# RCA-78-22-002-1: Inadequate GPS Antenna Signal

<b>Document Type</b>	Customer Satisfaction Campaign Bulletin
<b>Date</b>	February 22, 2022
<b>Affected Region(s)</b>	USA
<b>Affected Model(s)</b>	R1T
<b>Model Year(s)</b>	2022
<b>Approximate Build Dates</b>	September 2021 - October 2021
Refer to the FSA Dashboard to determine if this document applies to a specific vehicle.	
<b>Vehicle System</b>	78 - Low Voltage Electrical
<b>Minimum Service Location</b>	Service Center

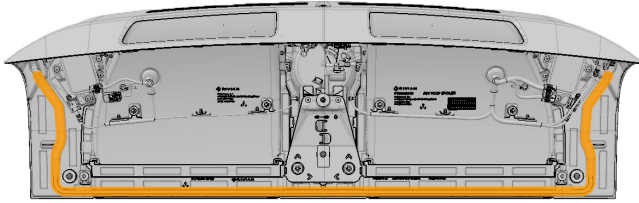
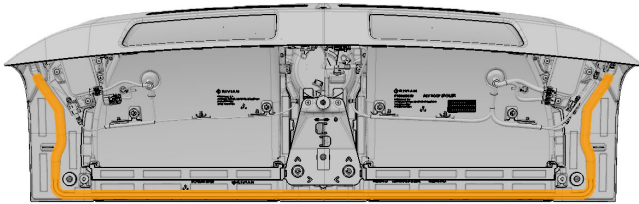
Rivian is initiating a customer satisfaction campaign for some model year 2022 R1T vehicles. The gear guard camera wiring, contained within the spoiler assembly, may emit an electrical signal noise to the nearby high precision global navigation satellite system (GNSS) antenna which is also contained within the spoiler assembly. The signal noise may result in a loss of the highway assist feature. If the highway assist feature is engaged when this condition occurs, the driver will receive a driver takeover request with a “Highway Ending Soon” message on the driver display. If the driver is attempting to engage highway assist, the “Highway Assist Not Available” notification will appear on the driver display. Rivian will replace the existing spoiler with a spoiler that has improved wiring that will not degrade the GNSS signal. Rivian is launching this campaign for customer satisfaction and to ensure the quality of Rivian vehicles.

Replace: Spoiler, Roof (refer to service manual procedure 603220010).

- Use only the primer and adhesives listed in this document.
- Check the expiration date label on the component. If the component is expired: Escalate for diagnostic assistance.
- Clean the highlighted area(s). Use alcohol wipes or rubbing alcohol on a clean cloth.

- Apply primer to the highlighted area.
